PLANNING COMMISSION AGENDA REPORT

MEETING DATE: APRIL 23, 2012 ITEM NUMBER: VI. 4

SUBJECT: PLANNING APPLICATION PA-11-28 AND TENTATIVE TRACT MAP 17435 FOR A SIX-UNIT COMMON INTEREST DEVELOPMENT AT 2070 MAPLE AVENUE

Site Plan

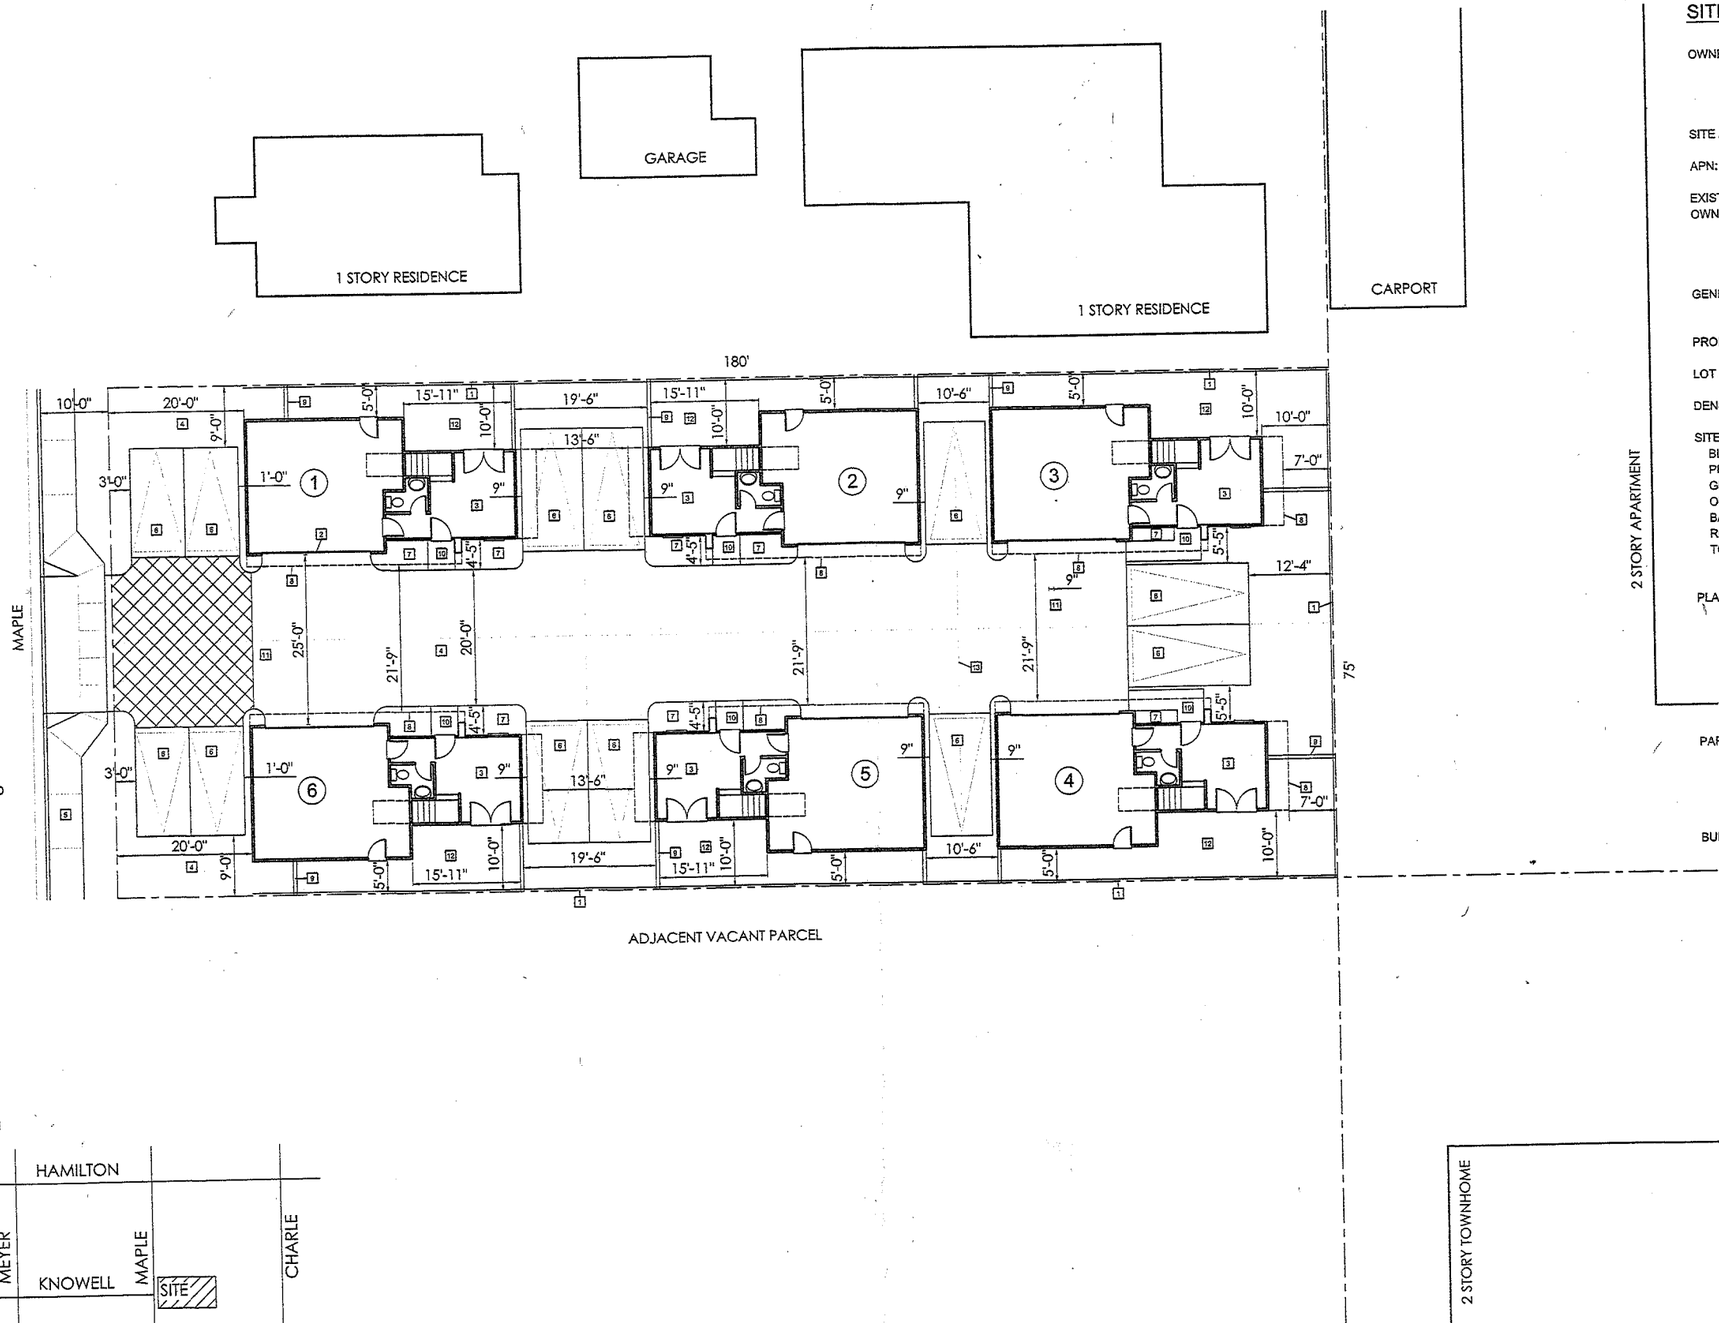
of these units with the CC&Rs. In addition, the four parking spaces proposed fronting the property are only eight feet wide and 16 feet long; the standard residential parking space is 8 ½ minimum feet wide and 18 feet long per code.

- *Deviation to allow parking within the front setback and reduce the overall open space to 30 percent.* Each unit is designed with a small private yard (10' x 16') and a side yard. The common driveway and parking areas cover about 40 percent of the site including the front landscape setback, which is reduced from 20 feet to three feet to allow for four parking spaces.

- *Deviation to allow reduced landscaping and small parking spaces in front landscape setback.* Four of proposed parking spaces are compact parking stalls and reduce the landscape setback to three feet (20-foot wide landscape area required, three-foot wide area proposed).

Parking is provided throughout the site; however, given the small lot size, the landscape setback on front is reduced. In addition, the four parking spaces are smaller than the standard parking stall (feet required, 8' x 16' proposed). The reduced landscape may be justified since the reduced setback is not applicable to the buildings and only to the landscaped area. The combination of private and public right-of-way landscaping will provide a 13-foot wide area adequate for installation of trees and shrubs to screen the parking from the street frontage.

Condition No. 15 requires that in addition to the proposed pavers for the driveways, all parking areas be finished with pavers for consistency and to improve the appearance of the site from the street and to minimize the runoff.

Condition Nos. 14 and 15 requires installation of additional trees throughout the site and Condition No. 19 requires that the compact parking spaces be marked and restrict parking of standard size vehicles with recordation of the CC&Rs.

TENTATIVE TRACT MAP AND PRELIMINARY GRADING PLAN
TTM No. 17435
2070 MAPLE AVENUE
APN No. 422-092-34

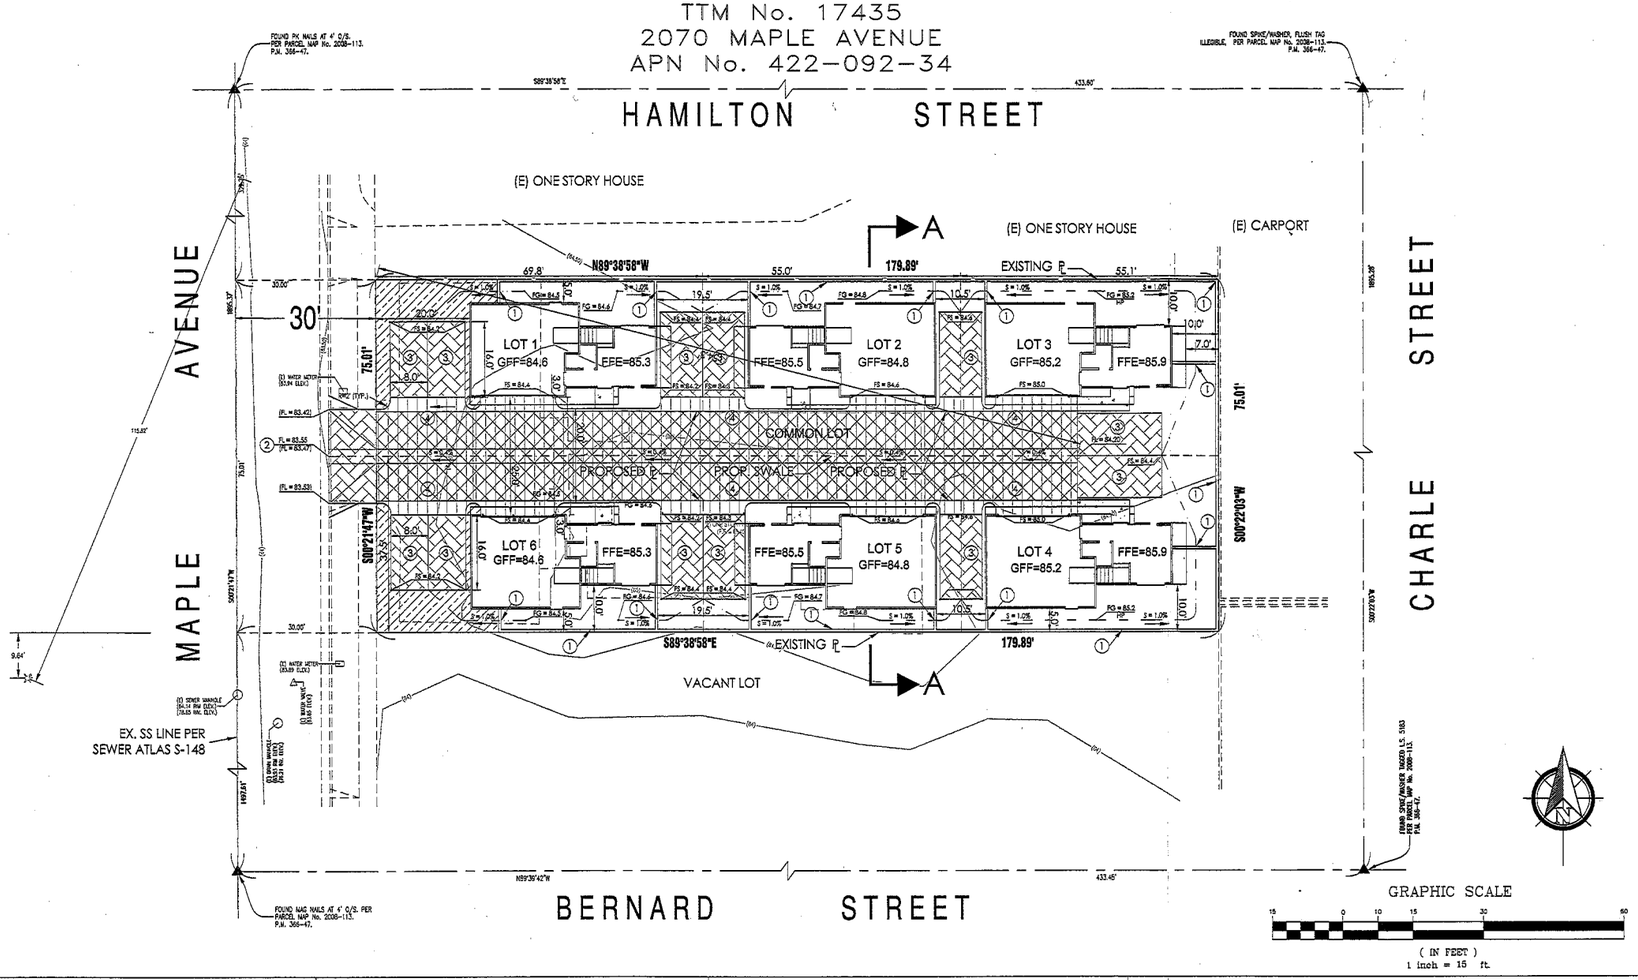
If approved for the proposed deviations, the property is physically suitable to accommodate the subdivision for condominium purposes. Engineering staff have confirmed that there are no interferences with the City's or other utility right-of-way areas and/or easements within the tract.
